dsPIC33EPXXGS50X Family Silicon Errata and Data Sheet Clarification

The dsPIC33EPXXGS50X family devices that you have received conform functionally to the current Device Data Sheet (DS70005127D), except for the anomalies described in this document.

The silicon issues discussed in the following pages are for silicon revisions with the Device and Revision IDs listed in [Table 1](#). The silicon issues are summarized in [Table 2](#).

FIGURE 1: EXAMPLE FOR REDUNDANT OUTPUT MODE

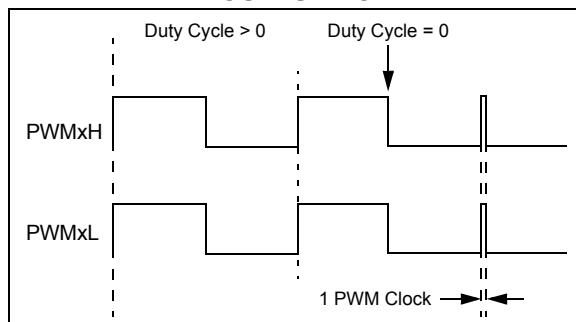
In the Redundant Output mode (IOCONx[11:10] = 0b01) and Push-Pull Output mode (IOCONx[11:10] = 0b10), with the Immediate Update Enable bit disabled (PWMCONx[0] = 0), when the Duty Cycle register is updated from a non-zero value to zero, a glitch pulse of a width equal to one PWM clock will appear at the next PWM period boundary, as shown in Figure 1 (for the Redundant Output mode). The Duty Cycle register refers to the PDCx register if PWMCONx[8] = 0 or the MDC register if PWMCONx[8] = 1.

If the application requires a zero duty cycle output, there are two possible work around methods:

1. Use the PWM override feature to override the PWM output to a low state instead of writing to the Duty Cycle register. In order to switch back to a non-zero duty cycle output, turn off the PWM override. The override-on and override-off events must be timed close to the PWM period boundary if the IOCONx register has been configured with IOCONx[0] = 0 (i.e., output overrides through the OVDDAT[1:0] bits occur on the next CPU clock boundary).
2. Enable the Immediate Update Enable bit (PWMCONx[0] = 1) while configuring the PWMx module (i.e., before enabling the PWMx module, PTCON[15] = 1). With the Immediate Update enabled, writes to the Duty Cycle register can have an immediate effect on the PWM output. Therefore, the duty cycle write operations must be timed close to the PWM period boundary in order to avoid distortions in the PWM output.

FIGURE 2:

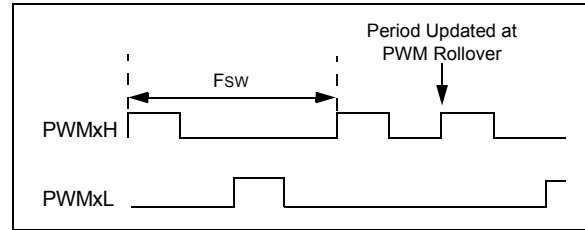
When the PWM module is configured for Push-Pull mode (IOCONx[11:10] = 0b10) with the Enable Immediate Period Update bit enabled (PTCON[10] = 1), a write to the Period register that coincides with the period rollover event may cause the push-pull output logic to produce back-to-back pulses on the PWMx pins (Figure 2).

Ensure that the update to the PWM Period register occurs away from the PWM rollover event by setting the EIPU bit (PTCON[10] = 1). Use either the PWM Special Event Trigger (SEVTCMP) or the PWM Primary Trigger (TRIGx) to generate a PWM Interrupt Service Routine (ISR) near the start of the PWM cycle. This ISR will ensure that period writes do not occur near the PWM period rollover event.

FIGURE 3: MISMATCH OF WORKING REGISTER SET WHEN NESTING MORE THAN ONE INTERRUPT WITHIN INTERRUPTS THAT USE ALTERNATE WORKING REGISTER SETS

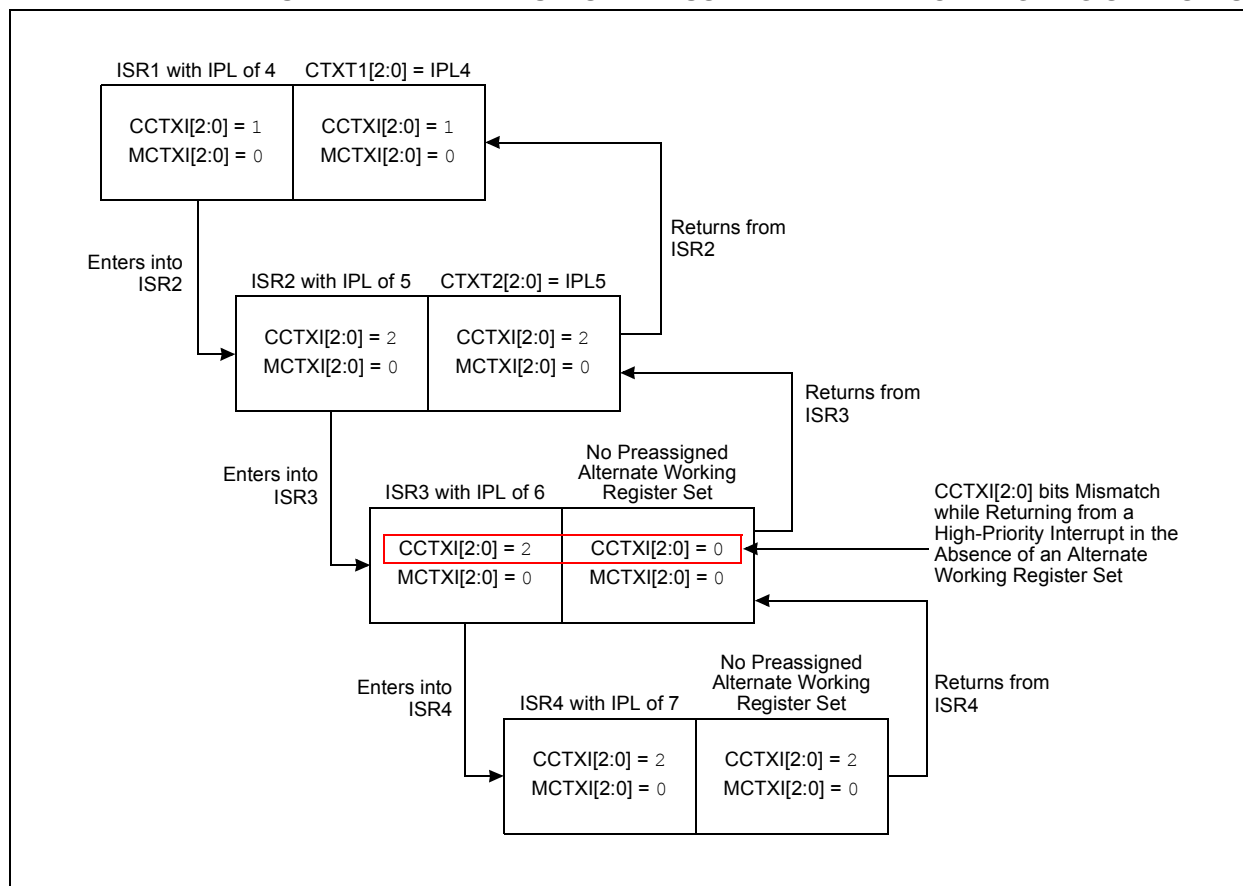
When returning from an Interrupt Service Routine (ISR) by executing the `RETFIE` instruction, in the case of a nested interrupt, the Interrupt Priority Control bits (`IPC[3:0]`) associated with the lower priority interrupt are compared with the `CTXTn` bits field in the `FLTREG` Configuration register:

- If there is a match with either of the `CTXTn` bits field, then the corresponding Alternate Working Register Set is chosen and the Current Context Identifier bits (`CCTXI[2:0]`) in the `CTXTSTAT` register are updated to reflect the new Alternate Working Register Set.
- If there is no match with either of the `CTXTn` bits field, then the expected behavior is to keep the context (defined by the value of the Current Context Identifier bits, `CCTXI[2:0]` in the `CTXTSTAT` register) unchanged. However, the

context gets changed. A new context, corresponding to the value in the Manual Context Identifier bits (`MCTXI[2:0]`) in the `CTXTSTAT` register, is selected by the hardware and the `CCTXI[2:0]` bits in the `CTXTSTAT` register are modified to reflect this change.

Issue and work around are illustrated in [Figure 3](#) and [Figure 4](#), respectively. The figures show the status bits, `CCTXI[2:0]` and `MCTXI[2:0]`, after entering into an ISR from a lower priority ISR (left pane), and after returning to the same ISR from a higher priority ISR (right pane).

FIGURE 5: SIMPLIFIED BEHAVIOR

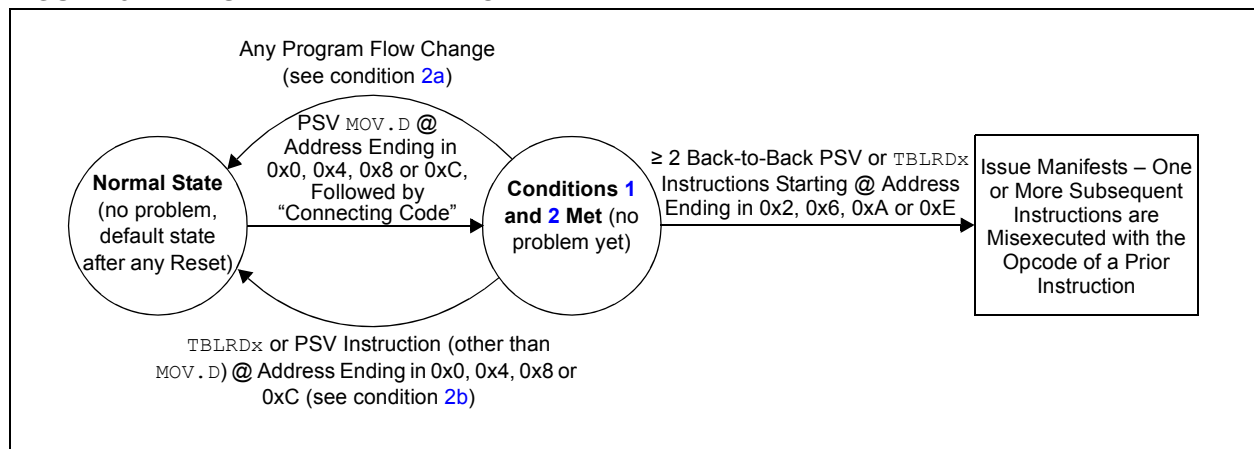
When two or more data Flash read instructions (via Program Space Visibility (PSV) read or table read) are executed back-to-back, one or more subsequent instructions can be misexecuted when all of the conditions in [Table 5](#) occur.

[Figure 5](#) provides an example of the effective behavior.

The issue can be avoided by ensuring any one or more of the requirements are not met. For example:

1. All instances of PSV `MOV.D` can be replaced with two PSV `MOV` instructions instead. Non-PSV `MOV.D` instructions acting on RAM/SFRs do not need to be modified; or
2. If not already present, a program flow change instruction (such as `BRA $+2`) can be inserted above back-to-back data Flash read sequences; or
3. Back-to-back data Flash read instruction sequences can be broken up by inserting a non-Flash read instruction (such as a `NOP`), in between the Flash read instructions; or
4. The alignment of the code can be shifted to avoid the required opcode location addresses.

28-Pin SOIC

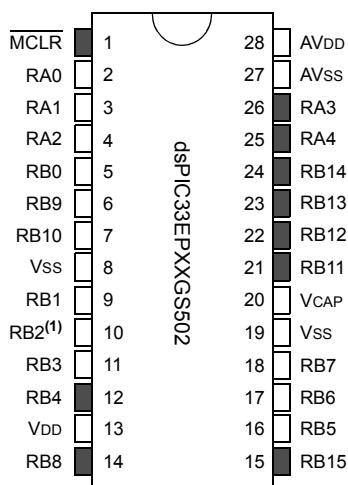
A note has been added to the RB2 port pin, as shown below in **bold**. This note applies to RB2 on all available packages.
